Urgent Device Correction

Elevated Temperature of Receive Coil Components When Using Select Ciné Treatment Imaging Sequences

UDC 2020-001

Figure 3: Distance between receive coil and inner surface of bore wall is more than 5 cm

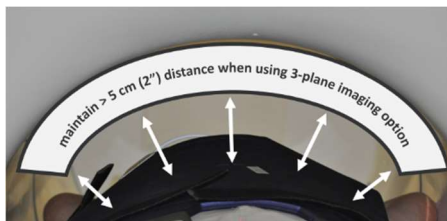
Do: Maintain a distance of at least 5 cm (~2") between the receive coil and the inner surface of the bore wall when using 3 Plane ciné treatment imaging (Figure 3 & 4).

Do Not: Select 3 Plane ciné treatment imaging if a distance of at least 5 cm (~2") cannot be maintained between the receive coil and the inner surface of the bore wall during treatment.
